Docket Number:	15-RETI-02
Project Title:	Renewable Energy Transmission Initiative 2.0
TN #:	212674
Document Title:	Bay Area Municipal Transmission Group's Comments on the Renewable Energy Transmission Initiative 2.0
Description:	N/A
Filer:	System
Organization:	Bay Area Municipal Transmission Group through Joyce Kinnear
Submitter Role:	Public Agency
Submission Date:	8/8/2016 1:30:06 PM
Docketed Date:	8/8/2016

Bay Area Municipal Transmission Group's Comments on the Renewable Energy Transmission Initiative 2.0 Transmission Technical Input Group July 29, 2016 Update

August 8, 2016

Figure 1: An Illustration of Interaction Between TAFAs

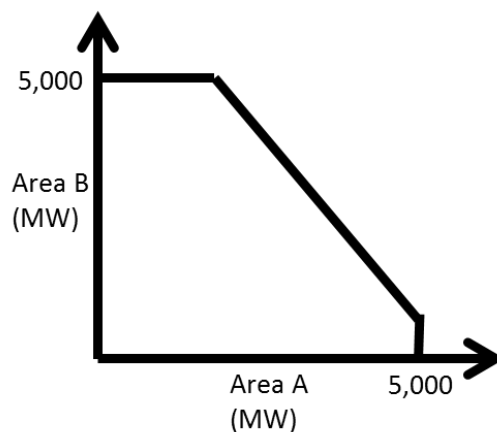
While the concept was clearly presented, the quantification of its application to the TAFAs was less clear. BAMx requests the TTIG to summarize the information on the transmission interaction between TAFAs in a table that both shows a “\$/kW” impact in terms of new transmission cost at 50%, 75% and 100% of the study (MW) range for each TAFE and notes those areas where there are nomograms between TAFAs such as the one identified in Figure 1. It is important to understand the incremental cost impacts of renewable energy development within the TAFAs to allow the construction of cost-effective resource portfolios.

To support the development of cost-effective resource portfolios, BAMx suggests that the transmission cost impact for Delivery Network Upgrades (DNU) needed to incrementally accommodate renewable resources in a given TAFE be organized as illustrated in Table 1 below. This Table reflects both incremental transmission cost impacts of resource development in a given TAFE (*TAFE A*) as well as the cumulative impacts of development in linked TAFAs for which a nomogram relationship exists (*TAFE B*).
